Clinton Power Station, Unit 1
Facility Operating License No. NPF-62
NRC Docket No. 50-461

Subject: Additional Information Supporting the Request for License Amendment
Related to Onsite Spent Fuel Storage Expansion

Heat Load and Rack Drop Analysis Results Supporting the Request for License Amendment Related to Onsite Spent Fuel Storage Expansion

FIGURE WS-1011

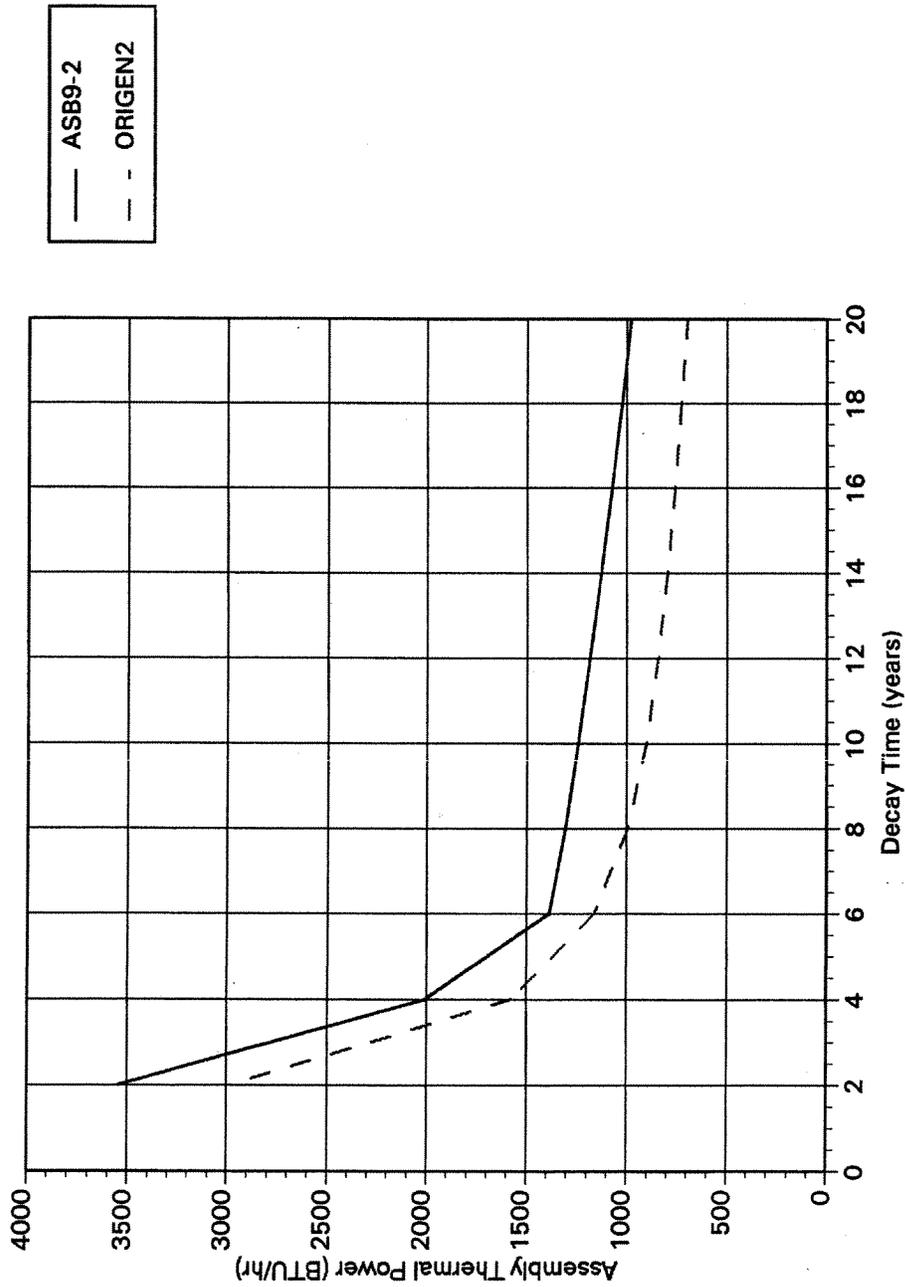
The NRC requested additional clarification on the responses provided, in the AmerGen letter dated June 14, 2005, to questions concerning the differences in decay heat and peak pool temperatures between the current analysis and the analysis performed to support the spent fuel pool expansion project. Specifically, the questions concerned how the maximum decay heat load and peak pool temperatures could be less, following the expansion of the spent fuel pool storage capacity, than the current values.

The expected agreement between ANSI/ANS 5.1 and ASB 9-2 is significant, as Holtec has performed a comparison between ASB 9-2 and computer code ORIGEN2 that was used to evaluate the CPS spent fuel storage expansion decay heat. This comparison of ASB 9-2 and ORIGEN2 was performed in 1995 for fuel from Millstone Unit 1, a BWR plant, so it is expected to be similar to the CPS fuel and operating conditions. The attached figure shows the comparison, which was performed for cooling times between 2 and 20 years. For cooling times on the order of years, ASB 9-2 significantly overestimates decay heat rates relative to ORIGEN2. This helps limit the increase in the background decay heat (i.e., from previously discharged fuel assemblies) that results from the increase in the number of stored fuel assemblies.

If qualitative extrapolation is applied at 2 and 20 years of cooling, the decay heats from ORIGEN2 are on the order of 14% and 20% lower, respectively, than those from ASB 9-2. While the reduction in the decay heat difference certainly does not change linearly with cooling time, we can estimate that a reduction at very low cooling times on the order of 4% to 5% is not unrealistic. As noted above, since the fuel transfer rate change accounts for approximately 3.8 MBtu/hr of the observed decay heat difference, the remainder (about 2.4 MBtu/hr) is due to the decay heat calculation methodology. This represents a reduction in decay heat of approximately 5%.
